ETSI SMG3 Plenary Meeting #7,
Madrid, Spain
13th – 15th March 2000

Title: CRs to 3G Work Item CAMEL Phase 2

03.18 CR A057

Subject: Correction of CF Notification

Figure 36b: Procedure Obtain_Routeing_Address (sheet 2)

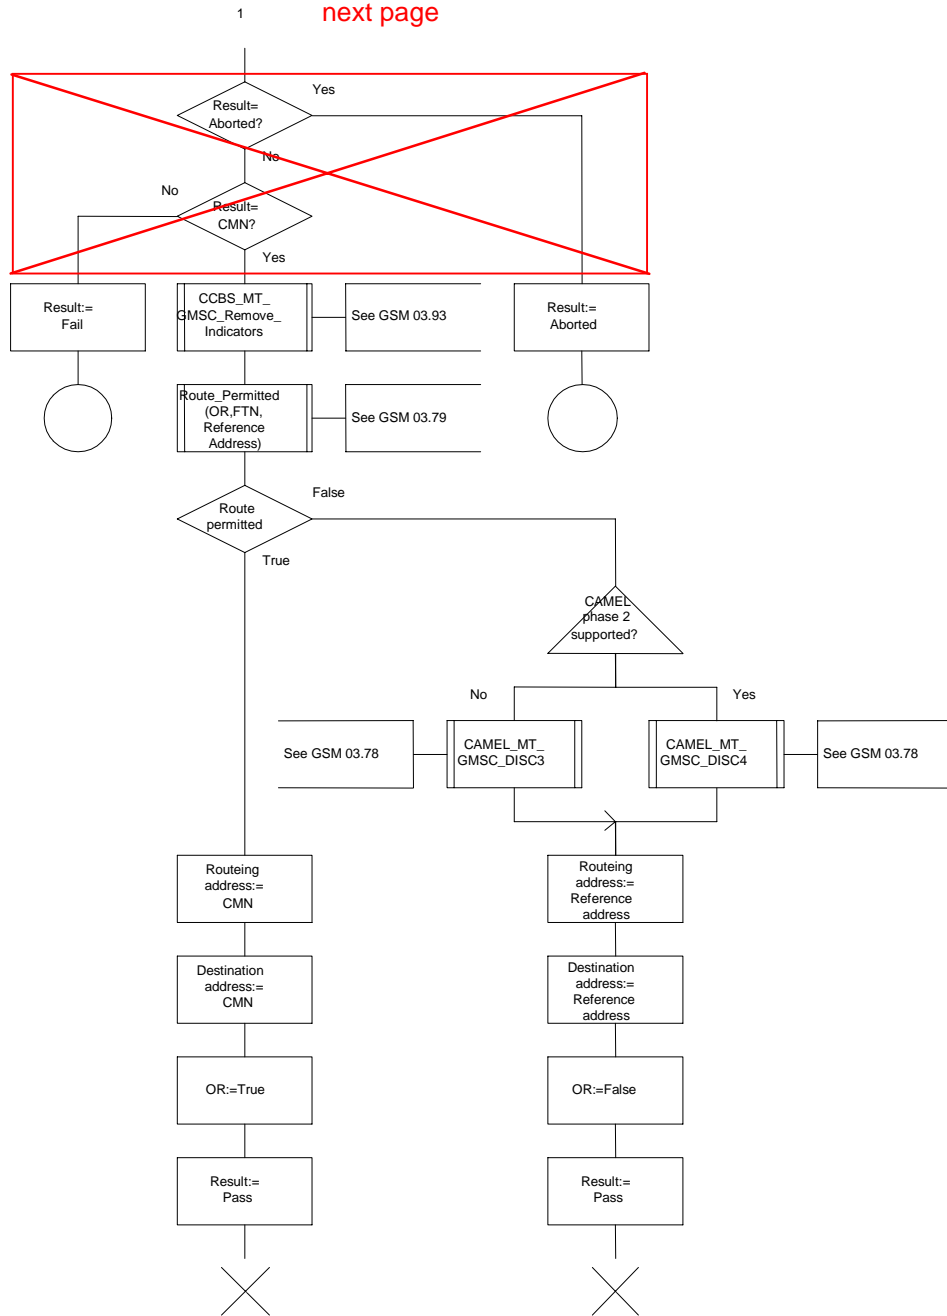
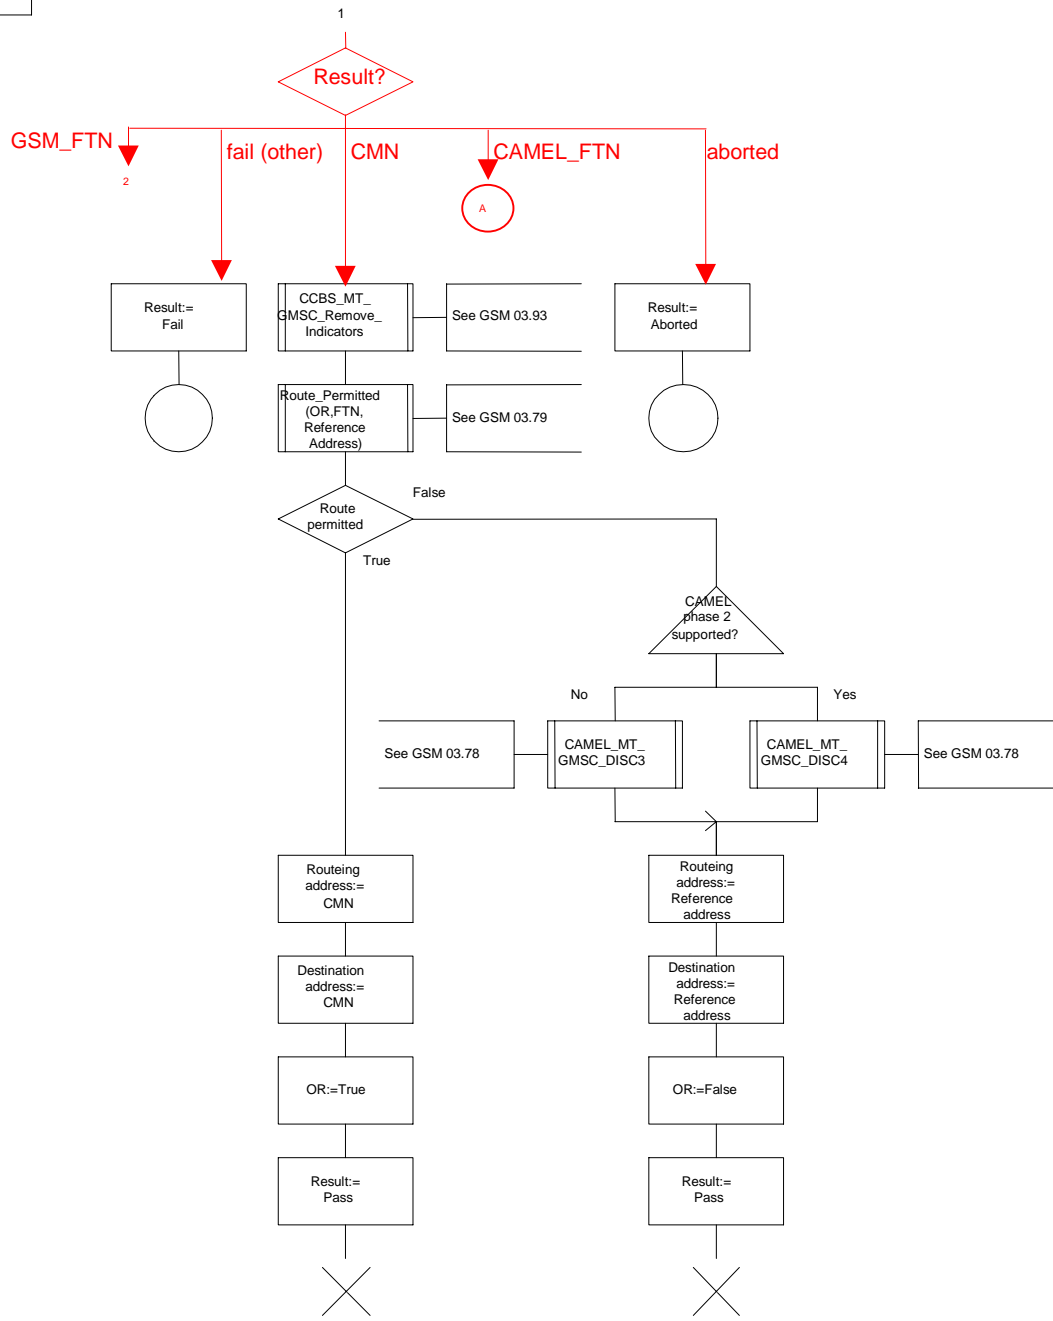
The proposal is to call procedure CAMEL_MT_GMSC_Notify_CF (in GSM TS 03.78) only for GSM-CF, i.e. gsmSCF shall not be notified about new Called Party Number being received from it in CONNECT.

Therefore a new outputs 'CAMEL_FTN' and 'GSM_FTN' are defined in Procedure CAMEL_MT_GMSC_INIT (in GSM TS 03.78). This is to be checked in procedure Obtain_Routeing_Address (in GSM TS 03.18). If result = 'CAMEL_FTN' procedure CAMEL_MT_GMSC_Notify_CF (in GSM TS 03.78) shall not be called. CF process shall be started instead.

Replace by the updated figure as shown on the next page

Figure 36c: Procedure Obtain_Routeing_Address (sheet 3)

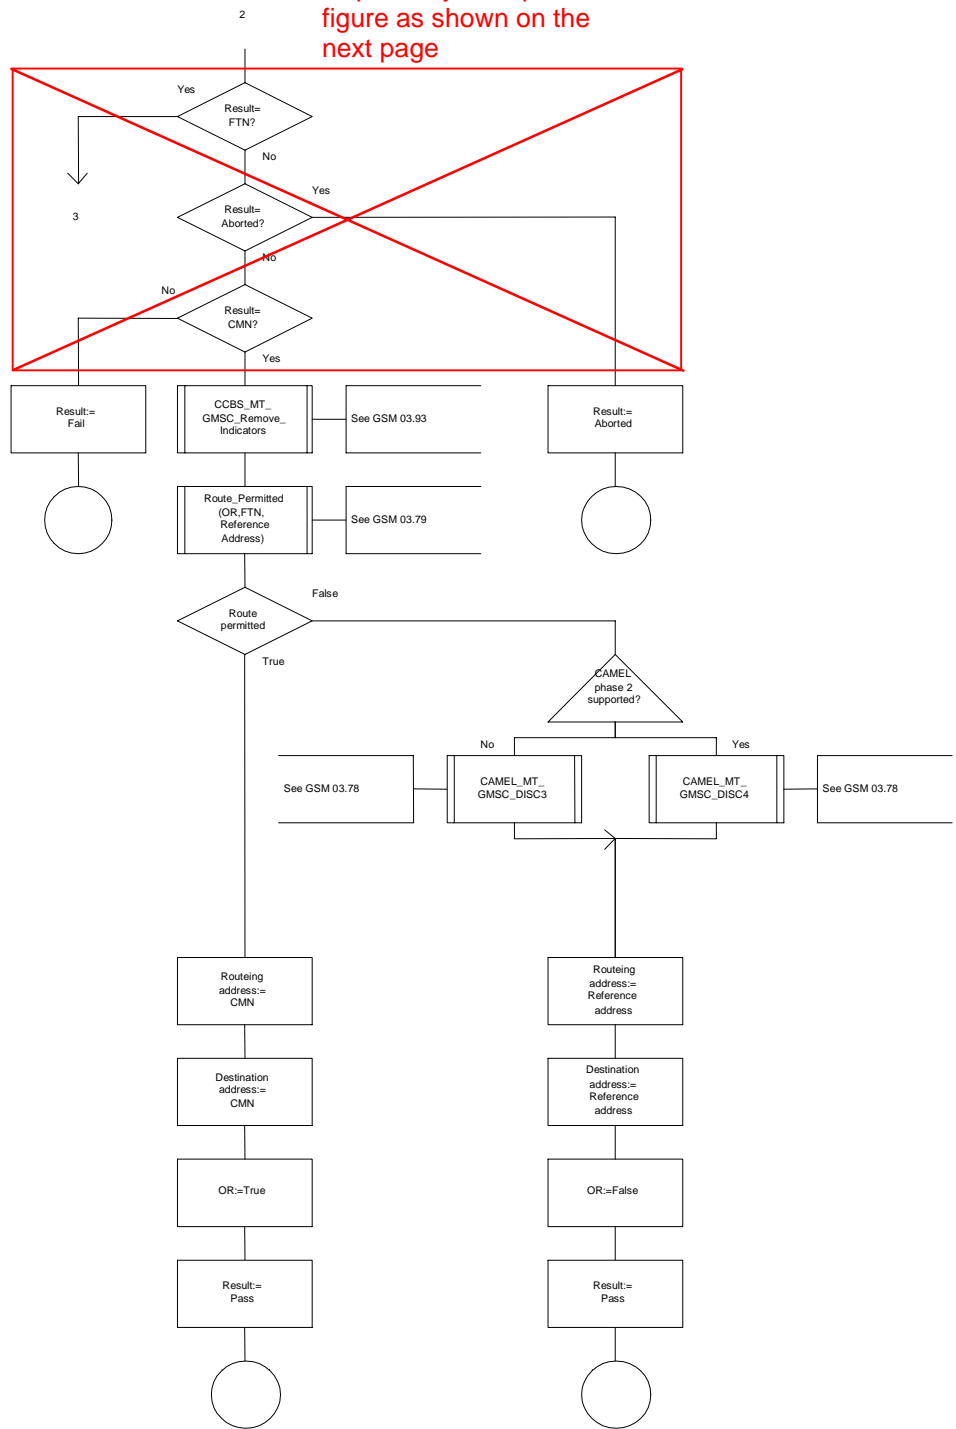
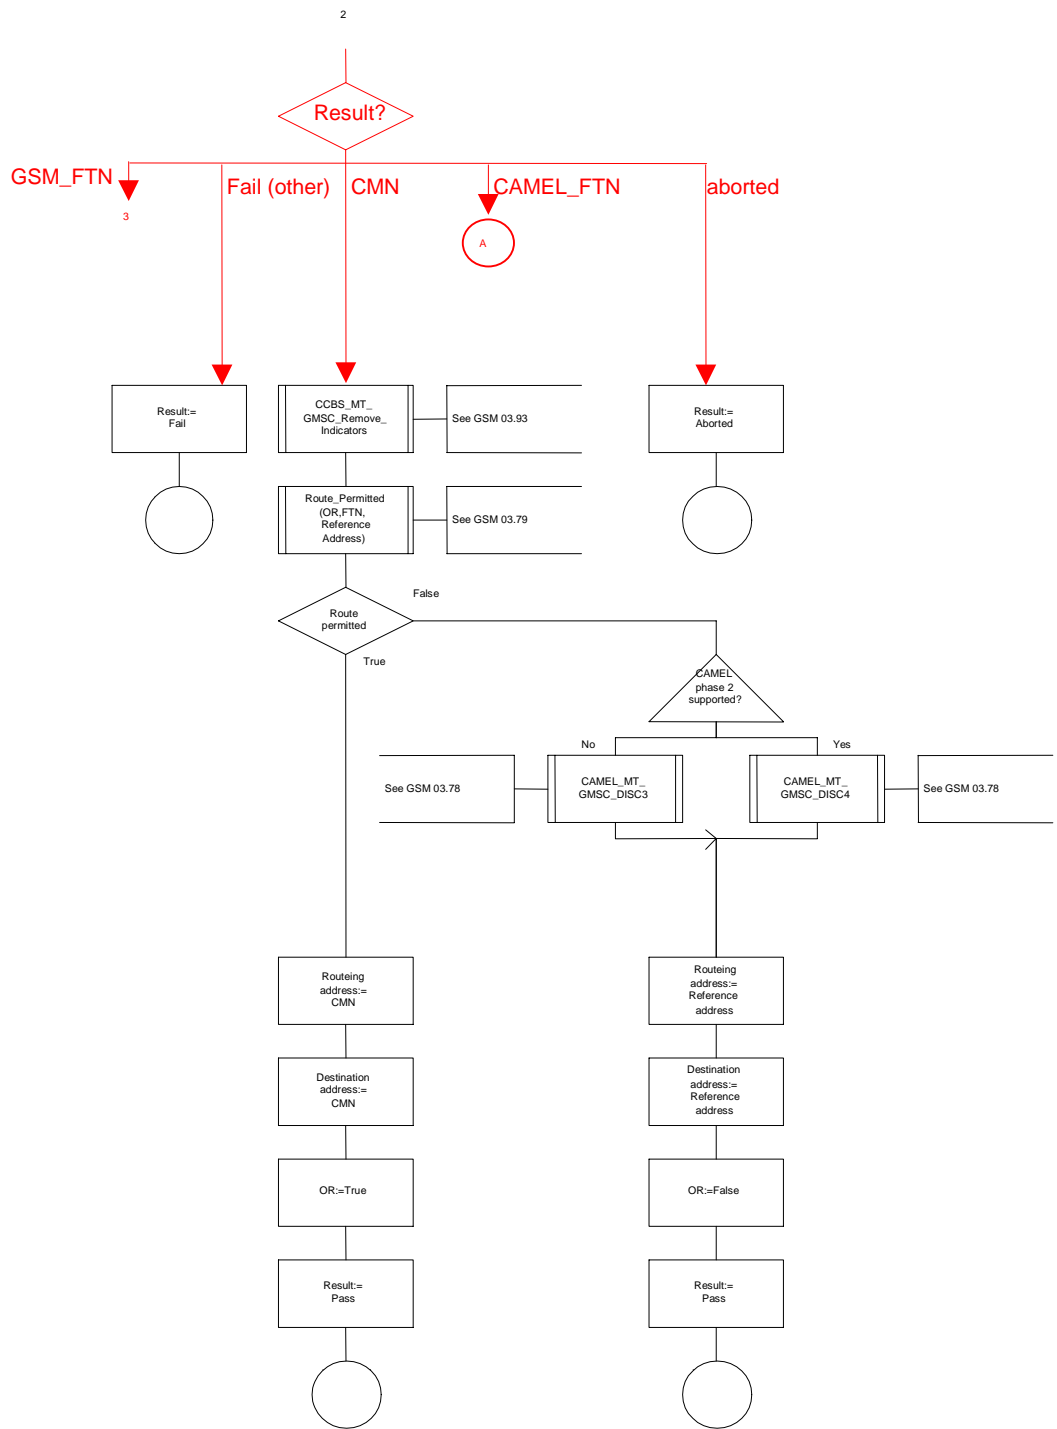
The proposal is to call procedure CAMEL_MT_GMSC_Notify_CF (in GSM TS 03.78) only for GSM-CF, i.e. gsmSCF shall not be notified about new Called Party Number being received from it in CONNECT.

Therefore a new outputs 'CAMEL_FTN' and 'GSM_FTN' are defined in Procedure CAMEL_MT_GMSC_INIT (in GSM TS 03.78). This is to be checked in procedure Obtain_Routeing_Address (in GSM TS 03.18). If result = 'CAMEL_FTN' procedure CAMEL_MT_GMSC_Notify_CF (in GSM TS 03.78) shall not be called. CF process shall be started instead.

Replace by the updated figure as shown on the next page

Figure 7a: Procedure OR_Handle_RCH (sheet 1)

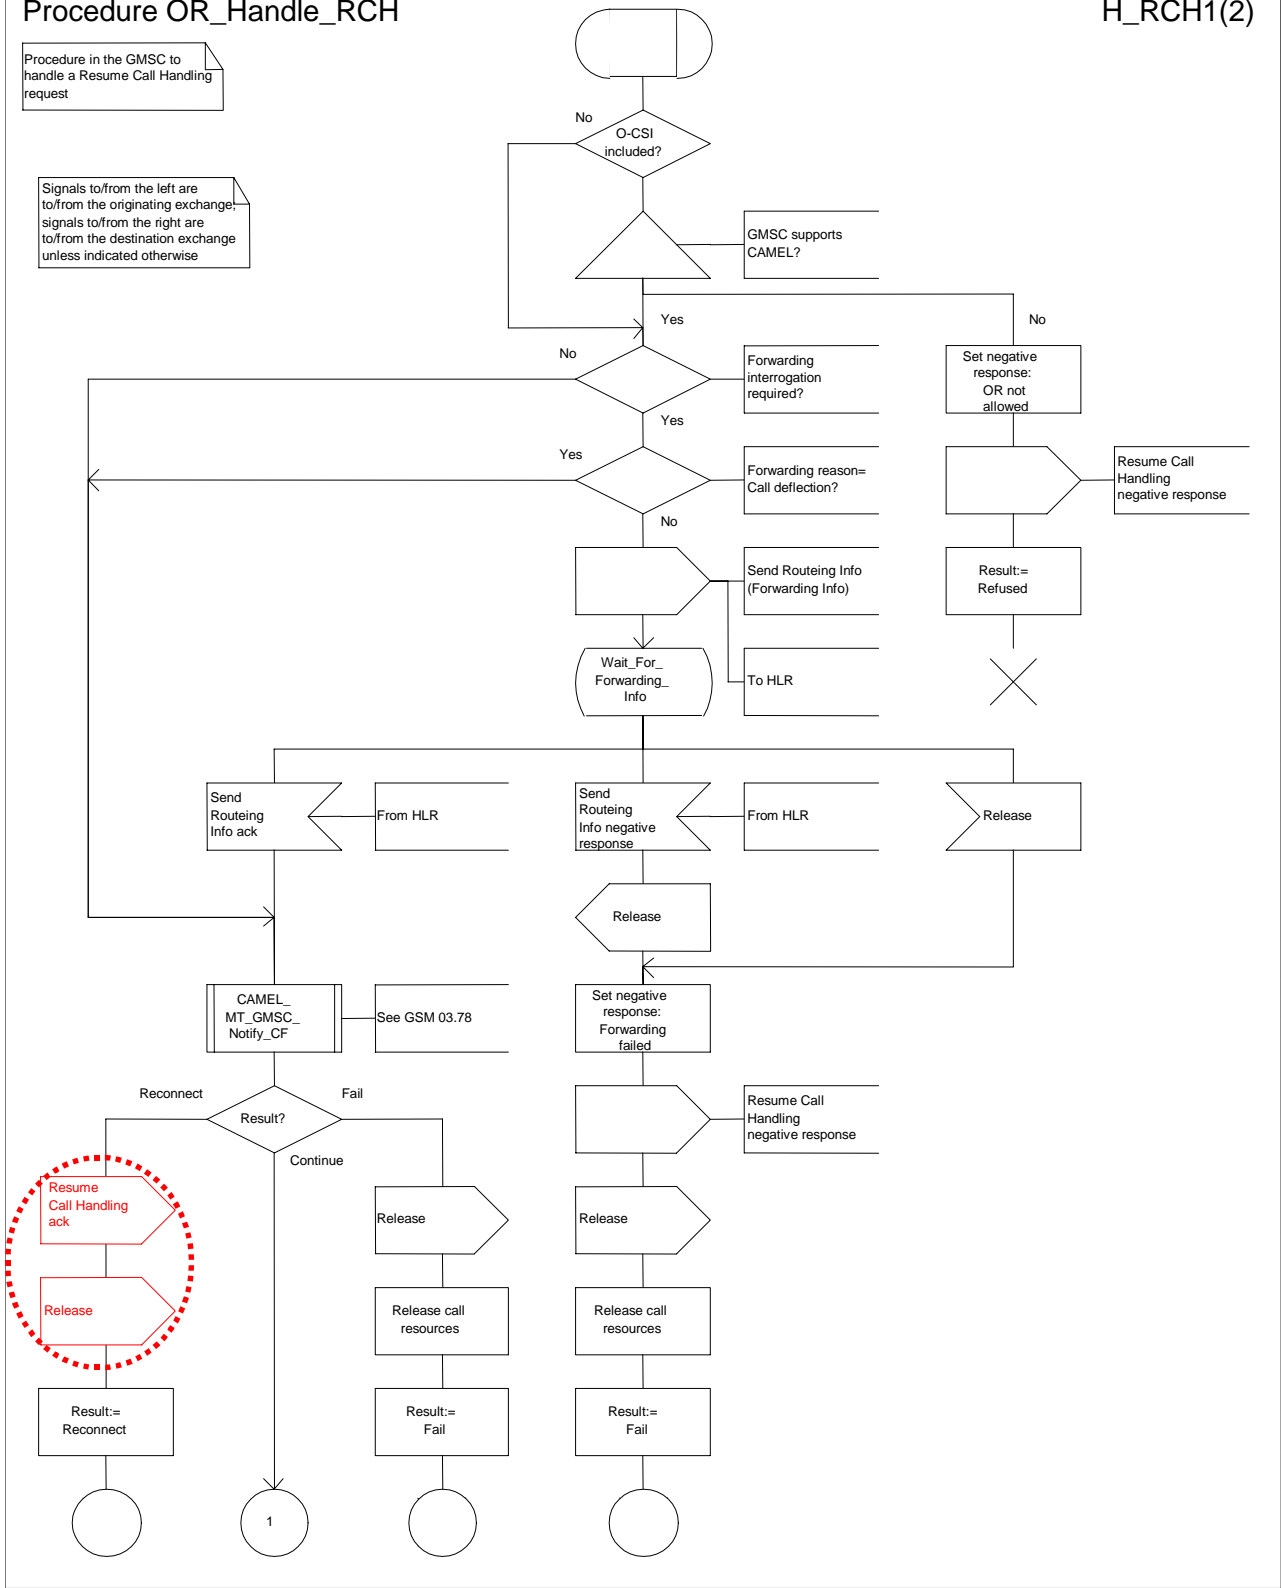
Last issue is the interworking with OR – when terminating logic is informed about ORLCF and sends a new Called Party Number in CONNECT then the connection to VMSC shall be released and RESUME CALL HANDLING shall be sent.

Figure 7a: Procedure OR_Handle_RCH (sheet 1)

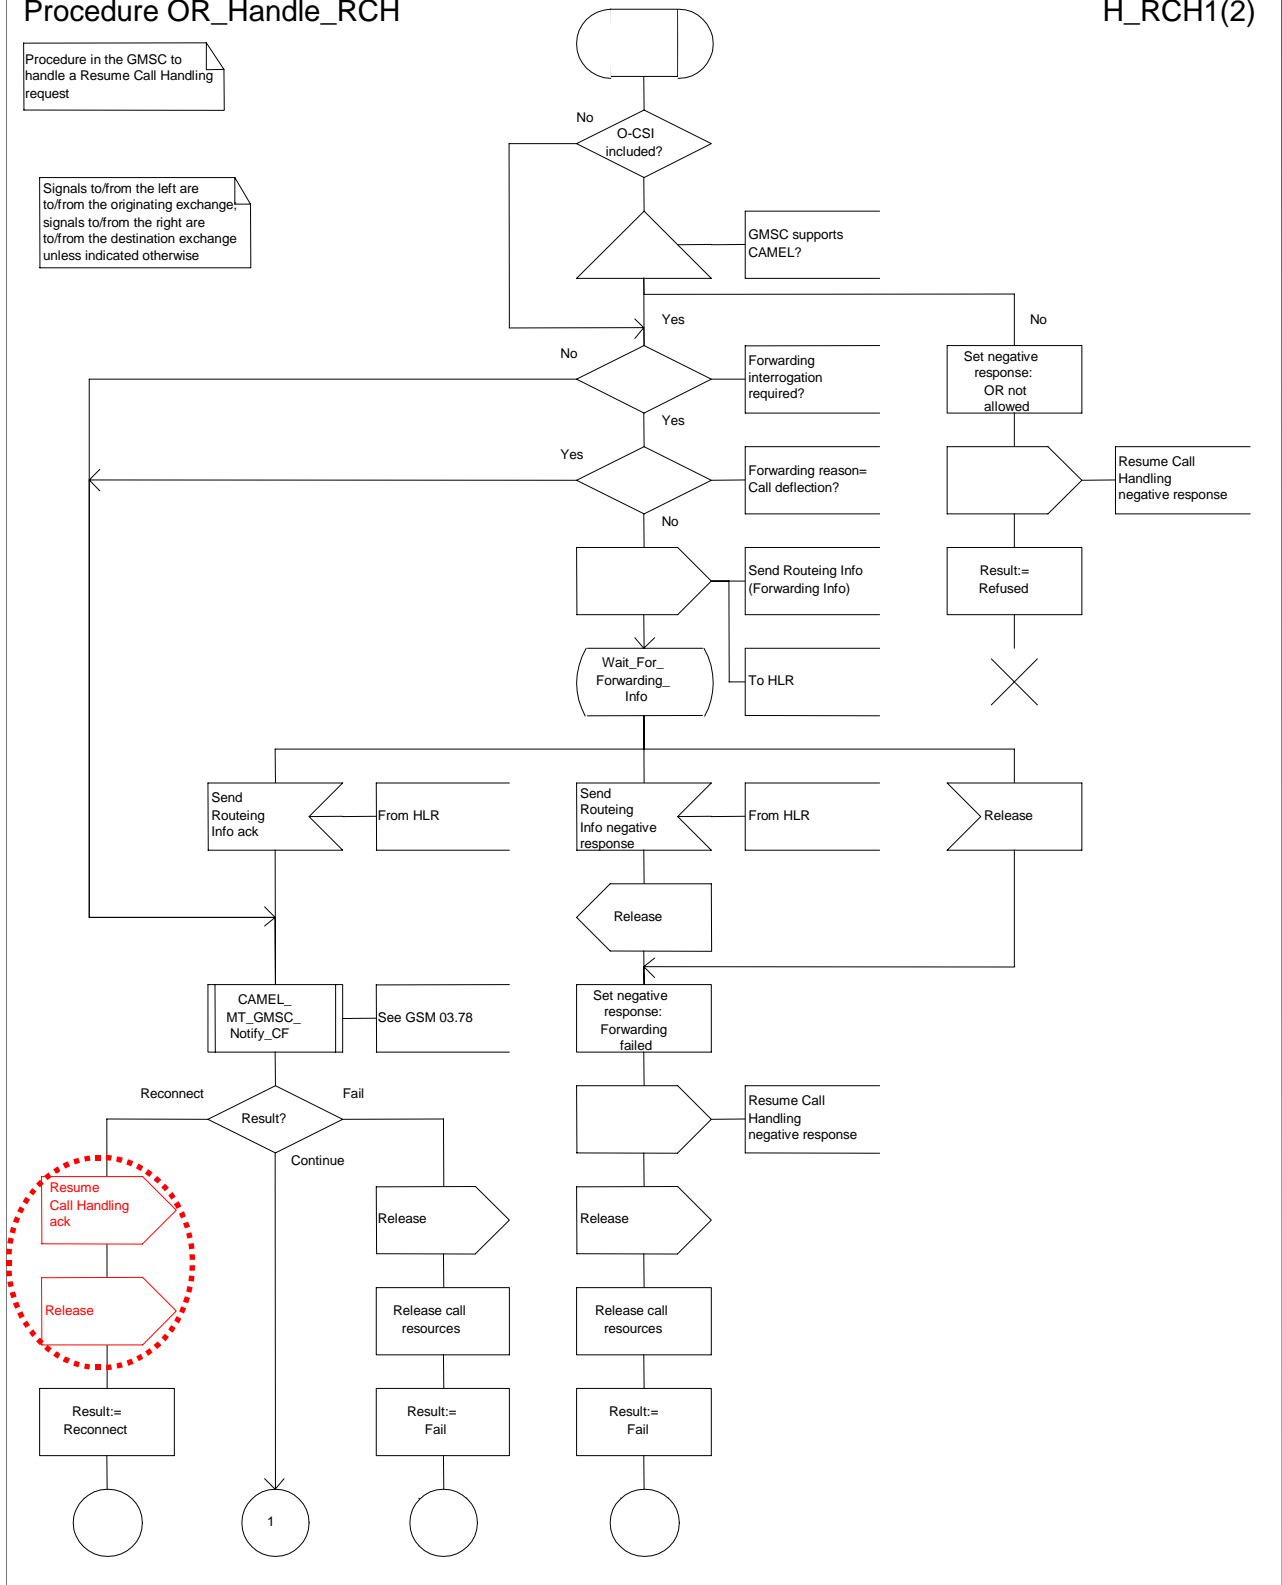
Last issue is the interworking with OR – when terminating logic is informed about ORLCF and sends a new Called Party Number in CONNECT then the connection to VMSC shall be released and RESUME CALL HANDLING shall be sent.
